Access Compliance Report

Public Rights-of-Way

Intersection ID: 47464	Main Street: SEASONS_CT	Cross Street: DOMINION_GREEN_DR	Location: E
ADA ID: A77B3EF94F51	Ramp Type: BlendTrans1	Initial Pass/Fail: Fail	Overall Compliance: No
Codes/Mitigation Info/Possible Solution		Field Measurements/Component Compliance	
Severity Score: 21.25

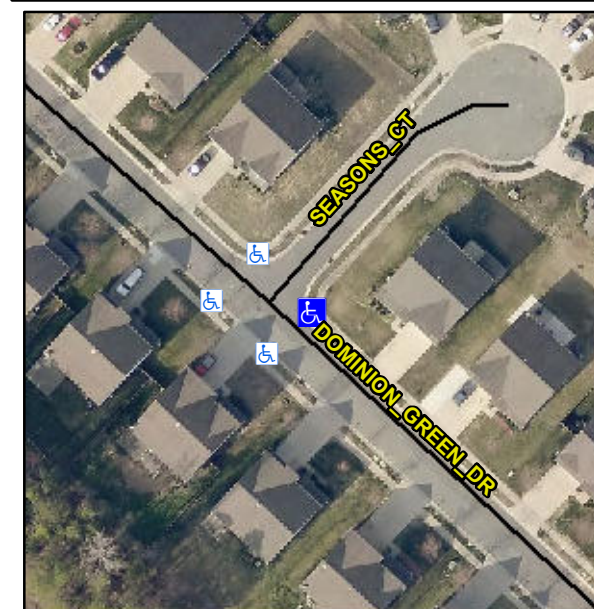
PROW/ADA:

R304.5.1, R304.5.3

Compliance	Description	Data	Compliance	Description	Data
N/A	Ramp Length (in)	47.0	Yes	BlendTrans Slope (%)	0.8
No	Ramp Width (in)	47.5	No	BlendTrans XSlope (%)	5.1
N/A	Flare Type LT	N/A	N/A	Flare Type RT	N/A
N/A	Flare Slope LT (%)	N/A	N/A	Flare Slope RT (%)	N/A
N/A	Flare Traversable LT?	N/A	N/A	Flare Traversable RT?	N/A
N/A	Landing Length (in)	N/A	N/A	DWS Provided?	N/A
N/A	Landing Width (in)	N/A	N/A	DWS Contrast?	N/A
N/A	Landing Slope (%)	N/A	N/A	DWS Length (in)	N/A
N/A	Landing X Slope (%)	N/A	N/A	DWS Full Width?	N/A
N/A	Landing Curb? (Y/N)	N/A	N/A	DWS Offset (in)	N/A
N/A	Shared Landing?	N/A			
N/A	Gutter Ponding?	N/A	N/A	Gutter Slope (%)	N/A
N/A	Gutter Lip Ht (in)	N/A	N/A	Gutter X Slope (%)	N/A
N/A	Painted X Walk1?	No	N/A	Painted X Walk2?	No
	X Walk 1 Direction	To NW		X Walk 2 Direction	To SW
	X Walk 1 Width (in)	N/A		X Walk 2 Width (in)	N/A
	X Walk 1 Slope (%)	7.1		X Walk 2 Slope (%)	2.3
	X Walk 1 X Slope (%)	3.8		X Walk 2 X Slope (%)	5.4

Remove & Replace Curb Ramp With Two New Directional Ramps or Equivalent.
